Memorandum

To	Le' Ann Whitehouse Seely, OALA, CSLA	Page 1
CC	Jana Joyce Associate, MBTW Group	
Subject	Gore Park Pedestrianization: Grading Review	
From	Ian Izzard, P.Eng., M.A.Sc. Project Manager	
Date	May 17, 2012	Project Number 60225470

KING STREET EAST
GORE PARK PEDESTRIANIZATION
GRADING REVIEW
CENTRAL GARDEN
From : James Street South
To : Hughson Street South

To	Jana Joyce, MBTW-Watchhorn	Page	1 of 4
CC			
Subject	Gore Park Utility review		
From	Ian Izzard		
Date	September 06, 2012	Project Number	60225470

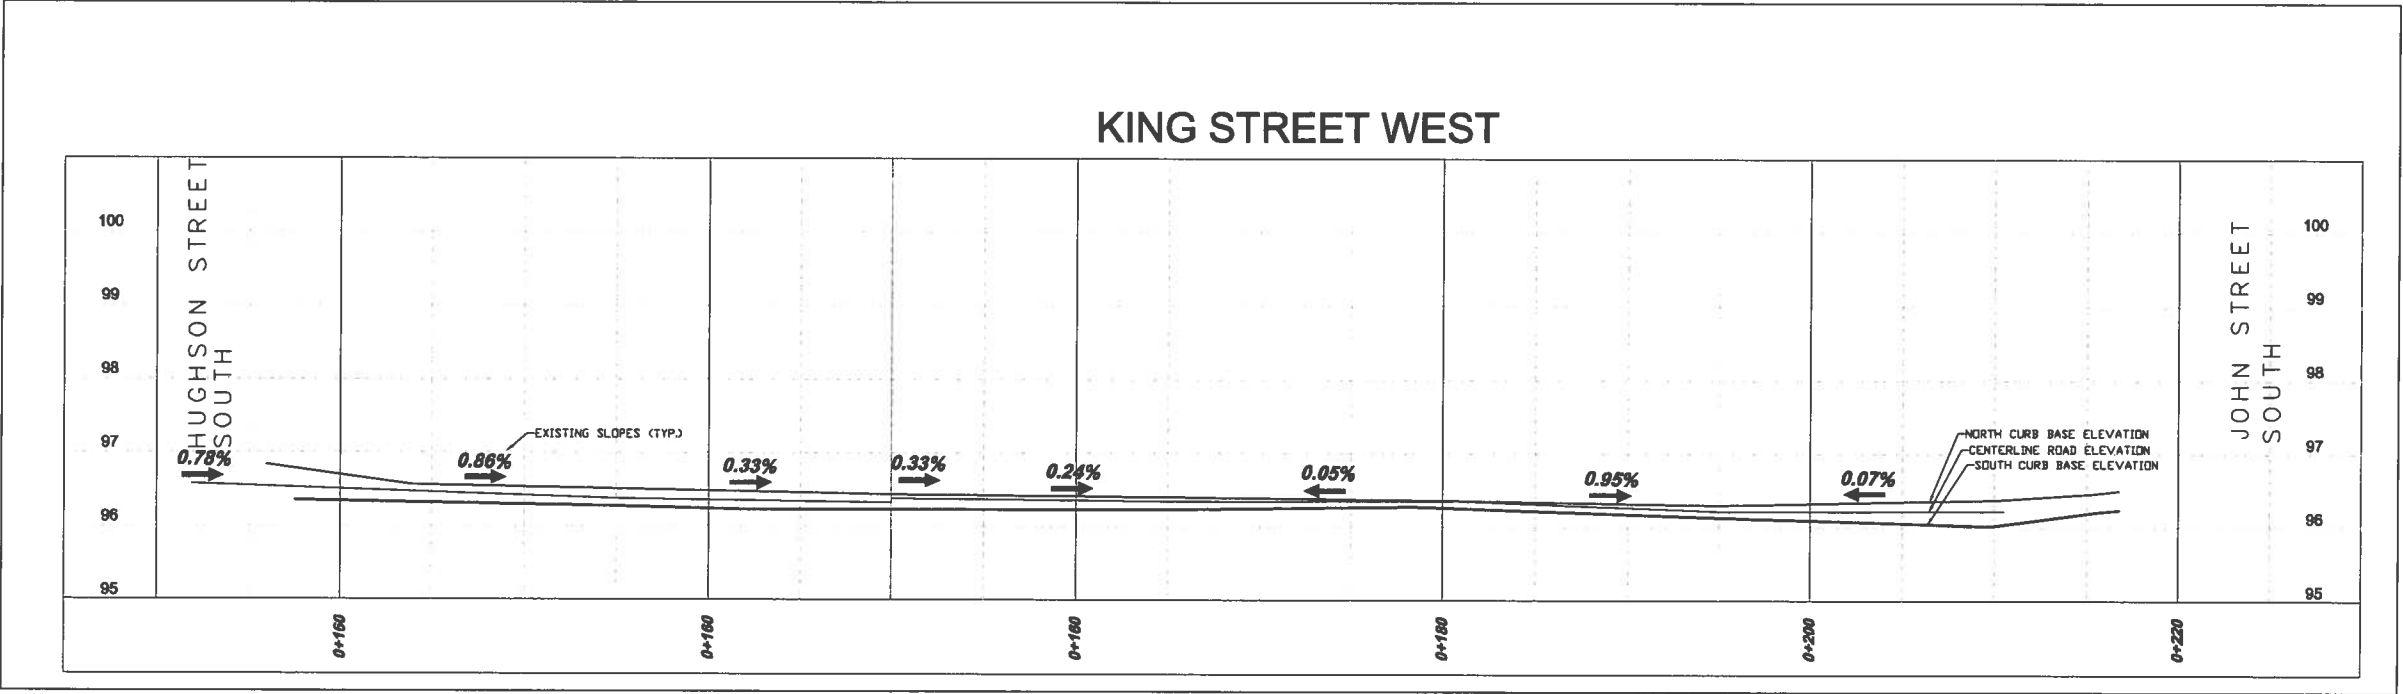
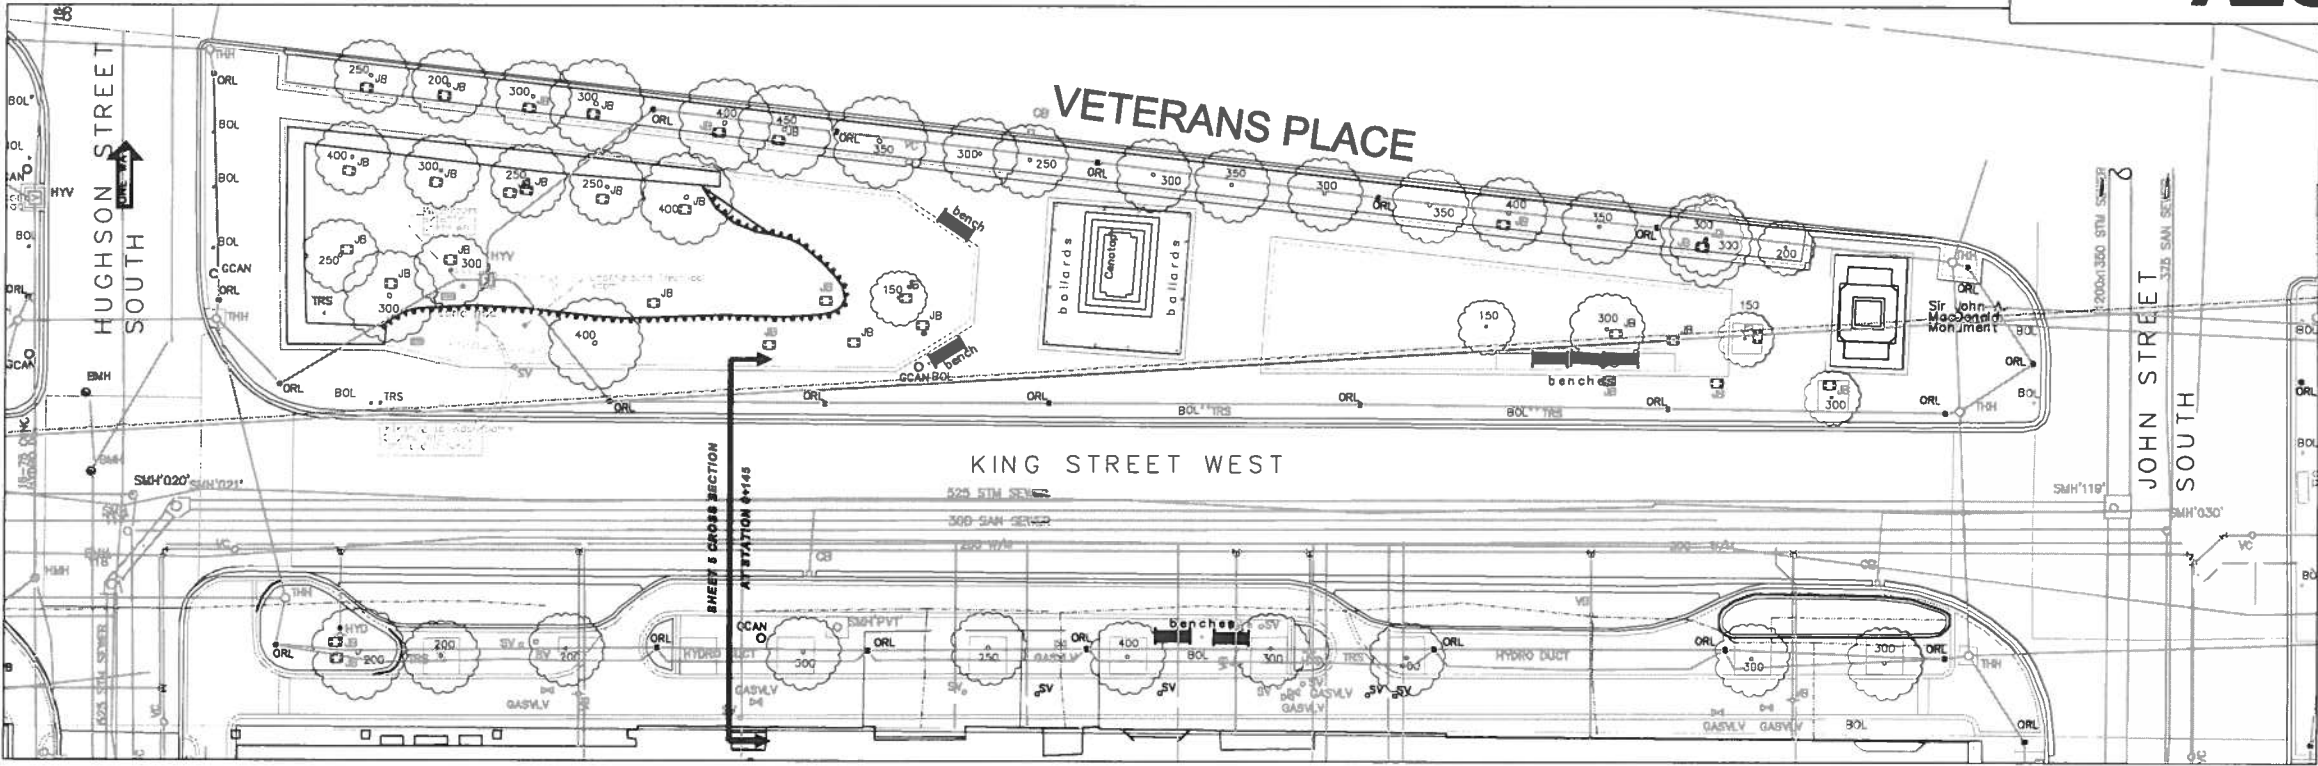
This section of the park runs from James Street to Hughson Street. The existing roadway is built with a crown of approximately 2% to the north and 4% to the south. There is a 150mm gutter on either side of the street. Two options were reviewed for the Pedestrianization of this block

Inverted crown	Full cross slope
Pedestrianization	Proposed road surface is flush with the existing sidewalk and curb	Proposed road surface is flush with the existing sidewalk and curb
Sub drains	New sub drain will have to be installed under the low point in the road to ensure drainage of the stone base under the road.	Roadway sub drain will remain in its present location and will ensure drainage of the stone base under the road.
Cross slope	2% cross fall as per City standards	1% cross fall, does not meet City standards
Water storage	Water storage from heavy storm may back-up within the existing roadway before it approaches the building.	Water storage from heavy storm may back-up on the sidewalk and approach the existing buildings.
Catch basins	Existing catch basins will be removed and replaced with new catch basins at the low point in the roadway.	Existing catch basins can remain in their existing location and be raised to the elevation of the proposed Pedestrianized road. Additional catch basins will be required between the existing catch basins.

KING STREET EAST
GORE PARK PEDESTRIANIZATION
GRADING REVIEW
VETERANS PLACE
From : Hughson Street South
To : John Street South

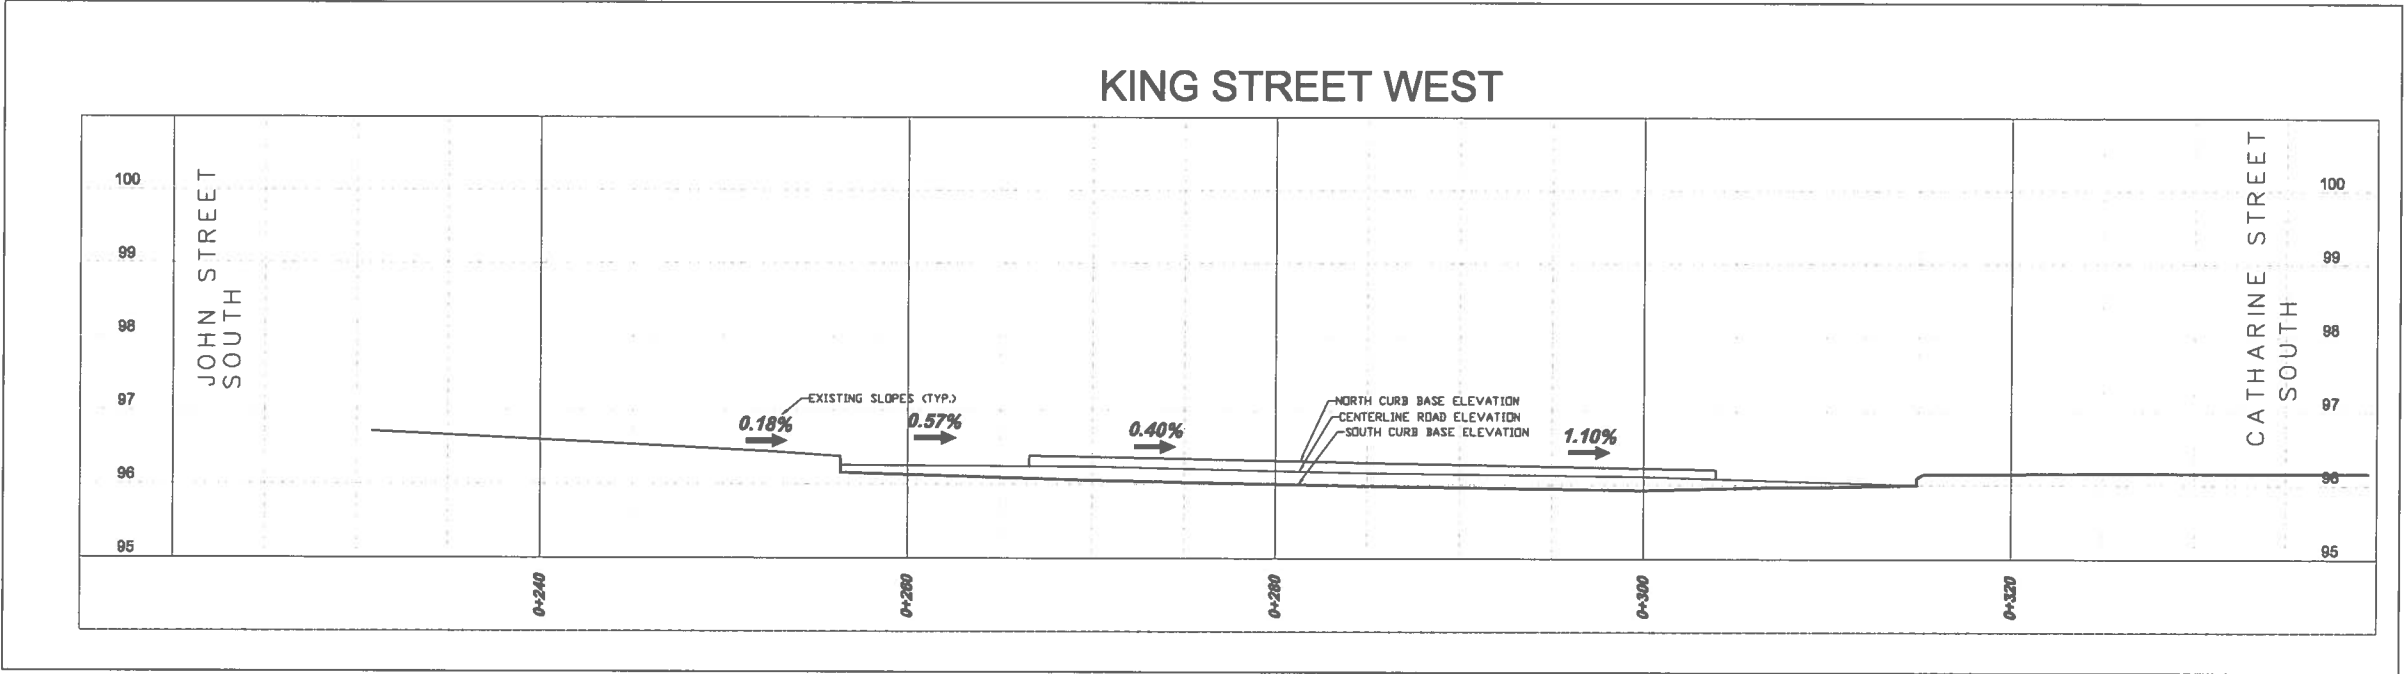
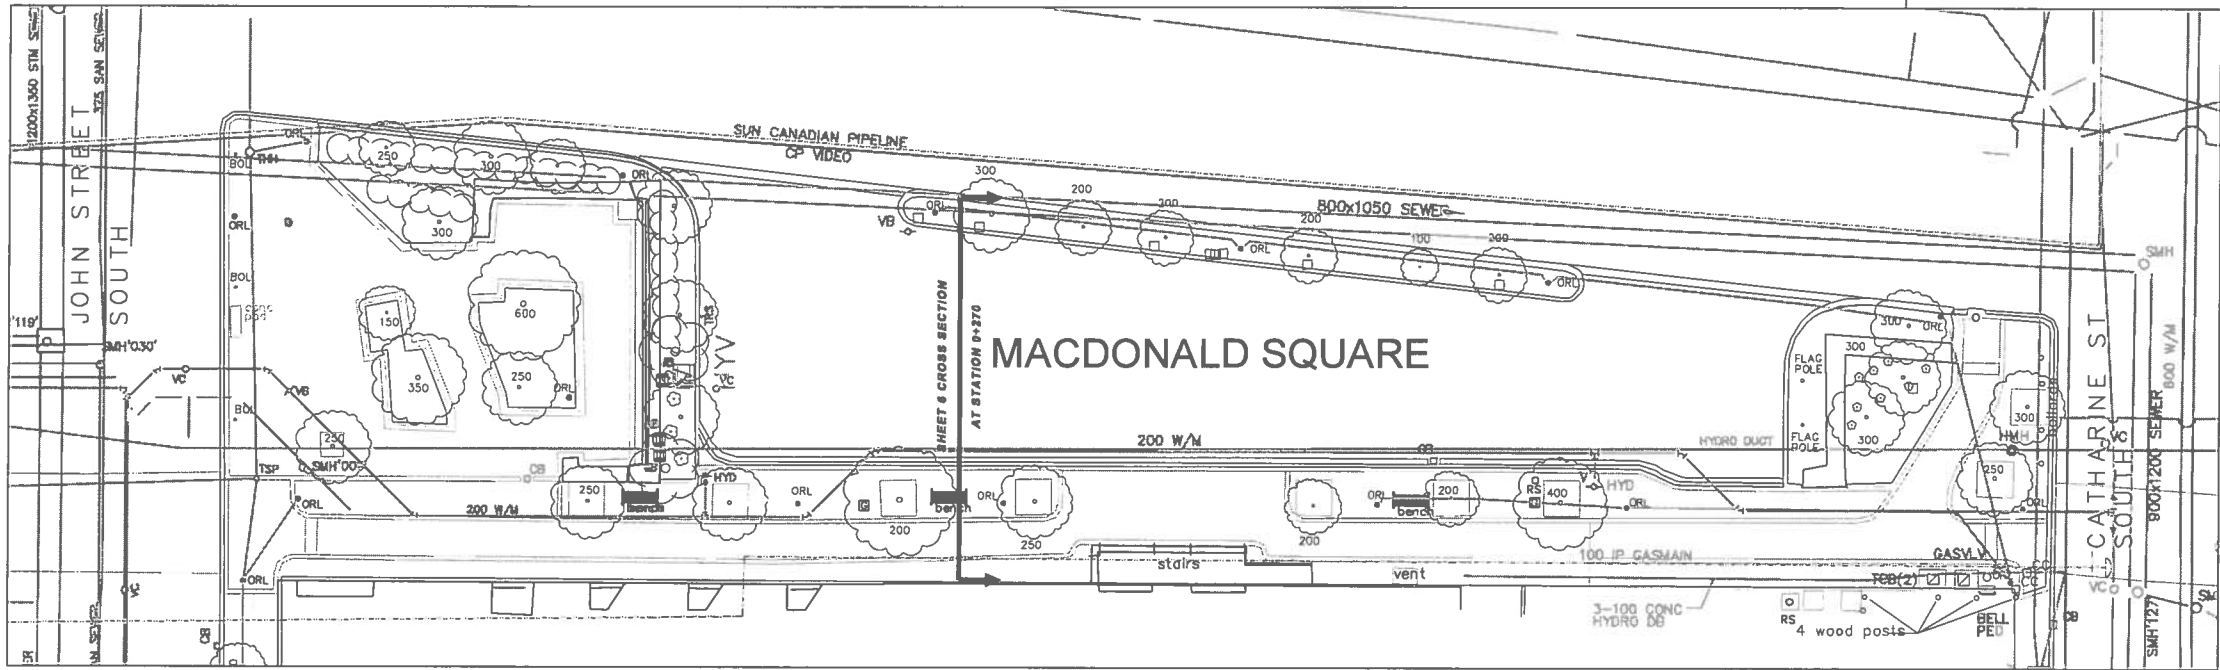
This section of the park runs from Hughson Street to John Street. The existing roadway is built with a cross slope of approximately 2% to the south. There is a 150mm gutter on either side of the street. Two options were reviewed for the Pedestrianization of this block

Inverted crown	Full cross slope
Pedestrianization	Proposed road surface is flush with the existing sidewalk. The north side curb will have to be lowered approximately 150mm to match the proposed slope. This additional depth will be accommodated in the proposed park renovations.	Proposed road surface is flush with the existing sidewalk and curb
Sub drains	New sub drain will have to be installed under the low point in the road to ensure drainage of the stone base under the road.	Roadway sub drain will remain in its present location and will ensure drainage of the stone base under the road.
Cross slope	2% cross fall as per City standards	2.6% cross fall, exceeds City standards but is acceptable
Water storage	Water storage from heavy storm may back-up within the existing roadway before it approaches the building.	Water storage from heavy storm may back-up on the sidewalk and approach the existing buildings.

Catch basins	Existing catch basins will be removed and replaced with new catch basins at the low point in the roadway.	Existing catch basins can remain in their existing location and be raised to the elevation of the proposed Pedestrianized road. Additional catch basins will be required between the existing catch basins.
